### NEEDHAM PLANNING BOARD

### Tuesday November 16, 2021 7:00 p.m.

7:20 p.m. Amendment to Major Project Site Plan Special Permit No. 2009-06: Town of Needham, 1471

8:30 p.m. Major Project Site Plan: Needham Enterprises, LLC, 105 Chestnut Street, Suite 28, Needham,

7185

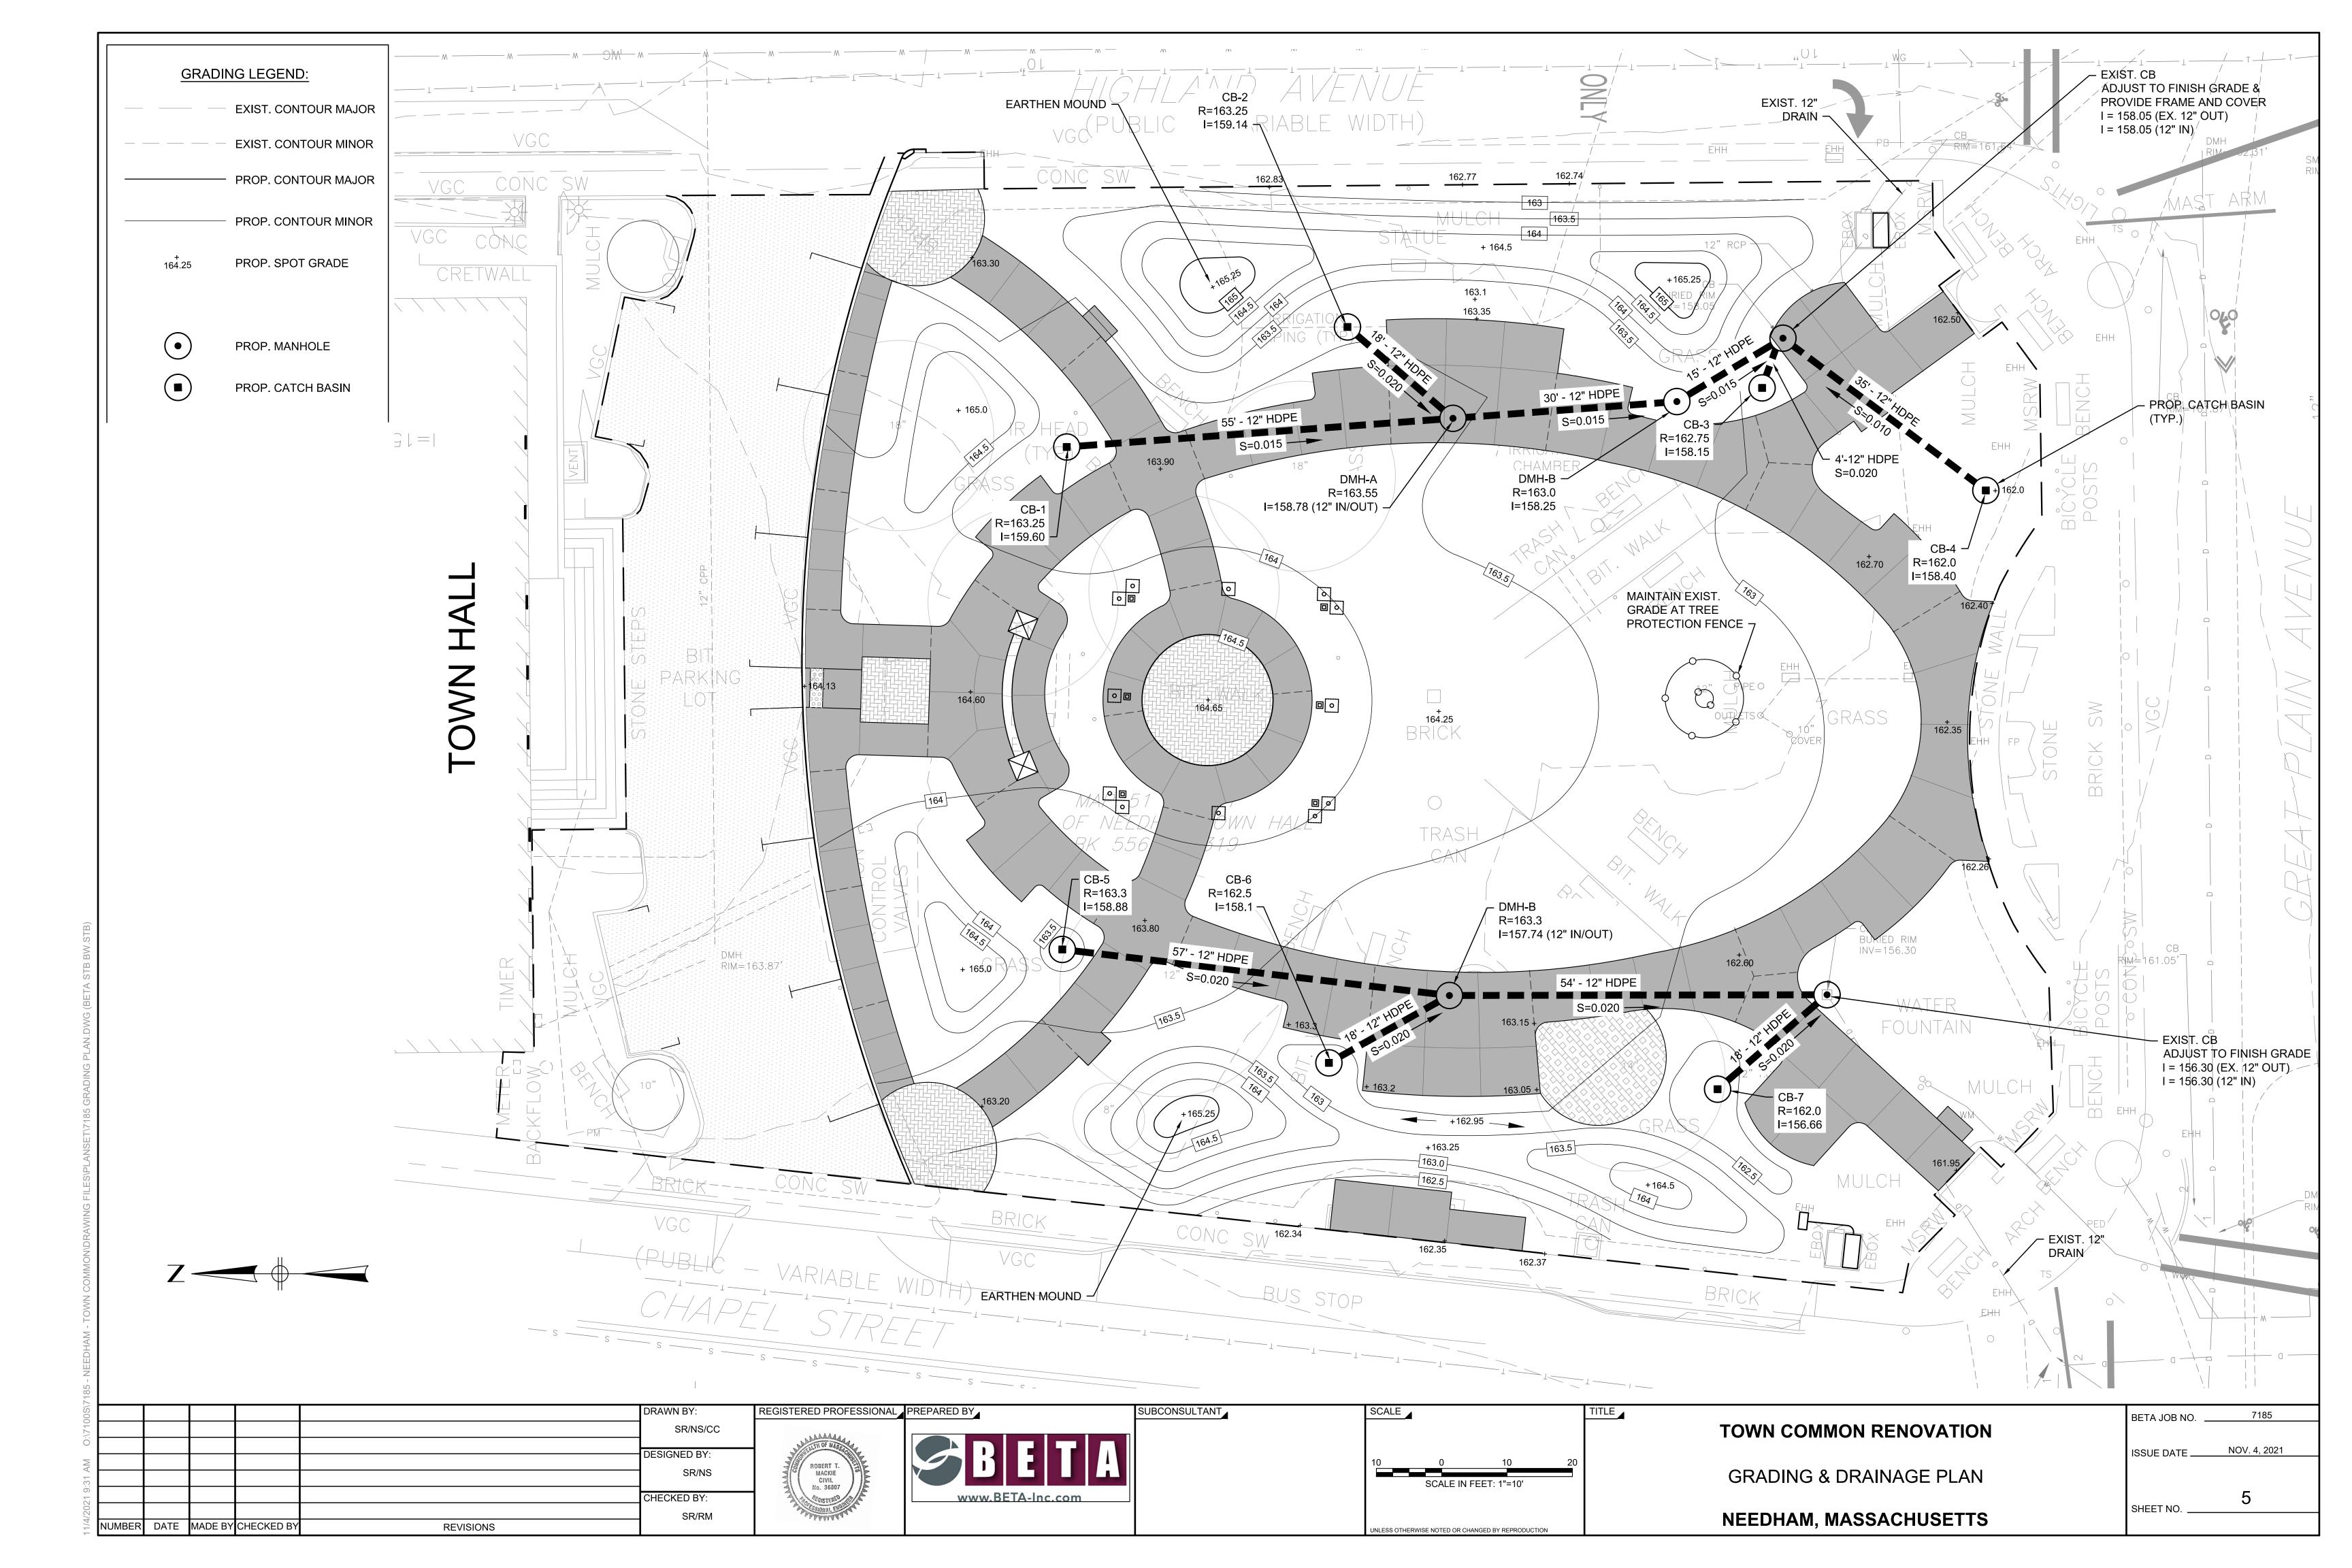
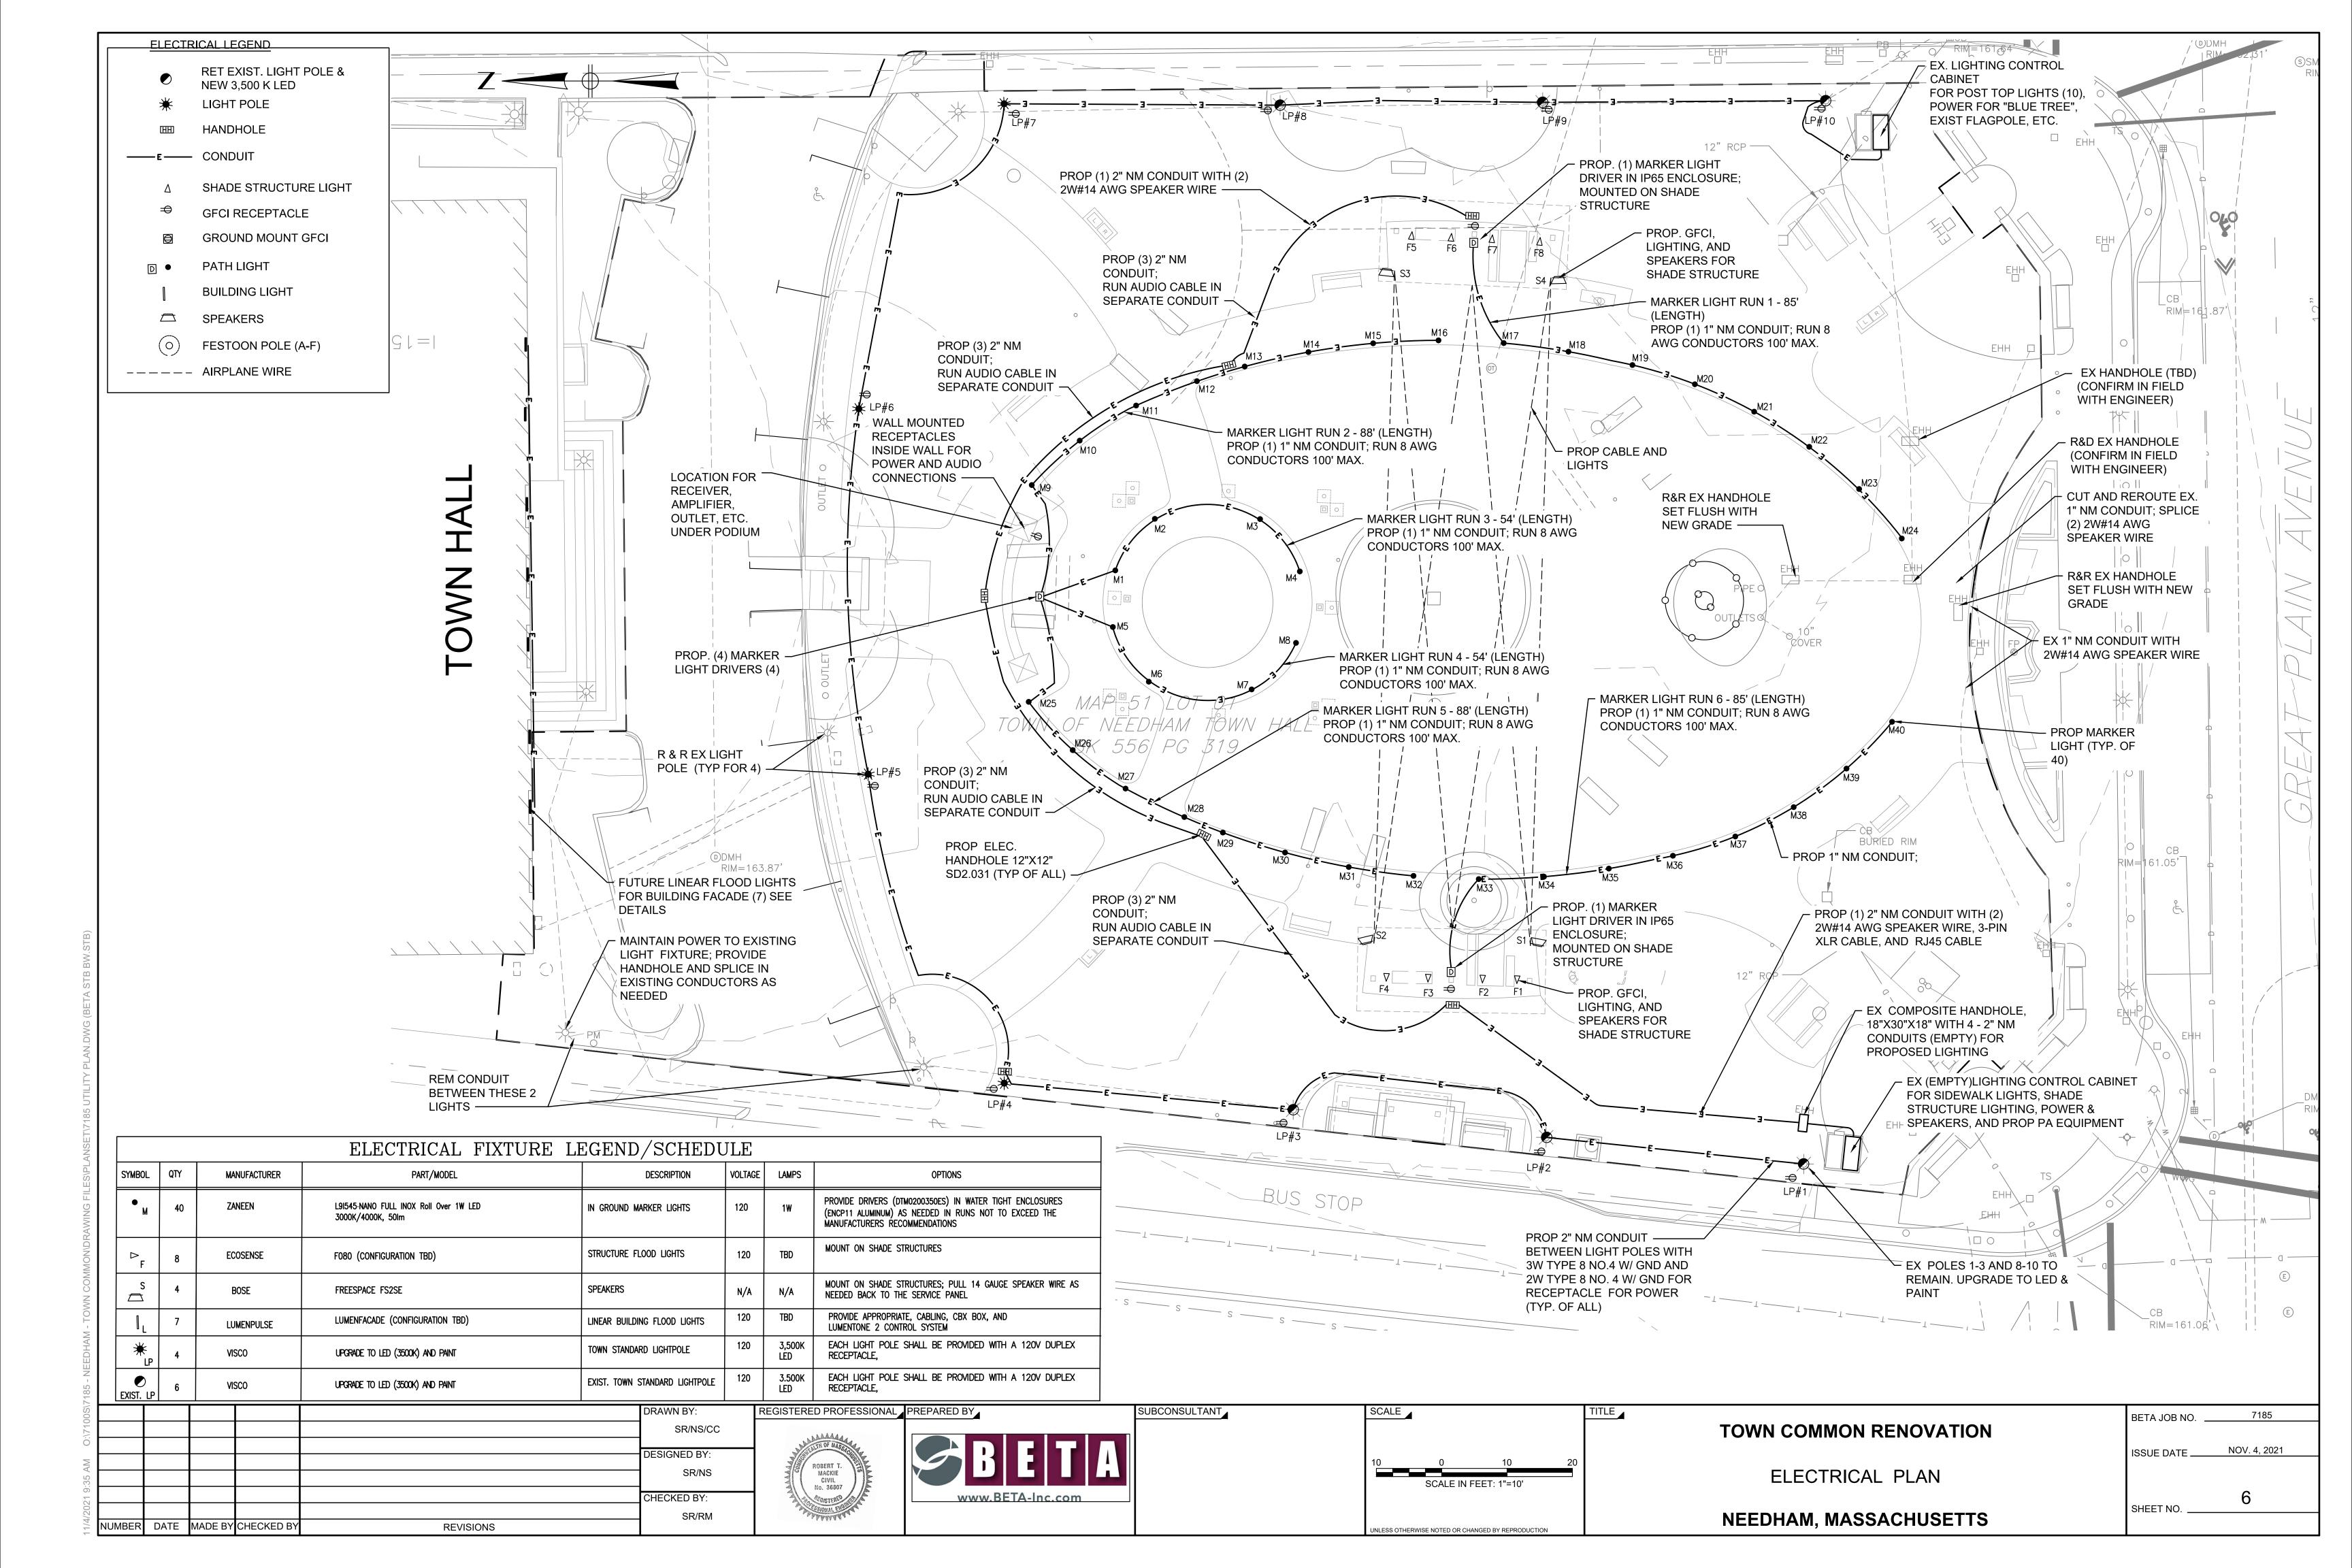
- The brick masonry seat wall at the north end of the site has been redesigned to include brick pillars on each end of the wall. The new pillars have been designed to be similar in appearance to the existing pillars at the end of the walls along Great Plain Avenue. One of the new pillars will be constructed to house PA outlets, wiring, etc. for use during events on the Common. The PA equipment itself will be stored inside Town Hall when not in active use during events. Renderings of the redesigned wall are included as figure (a) below, and on Sheet 12 (Details) of the revised plan set.

- The six (6) temporary festoon poles shown on the original plans have been removed, although the temporary festoon lighting will remain. In place of the free-standing poles, the proposed shade structures located on the east and west sides of the lawn will now include fixtures upon which cables and festoon lights can be affixed. This is illustrated on figure (b) below, and on Sheet 6 (Electrical Plan) of the revised plan set.
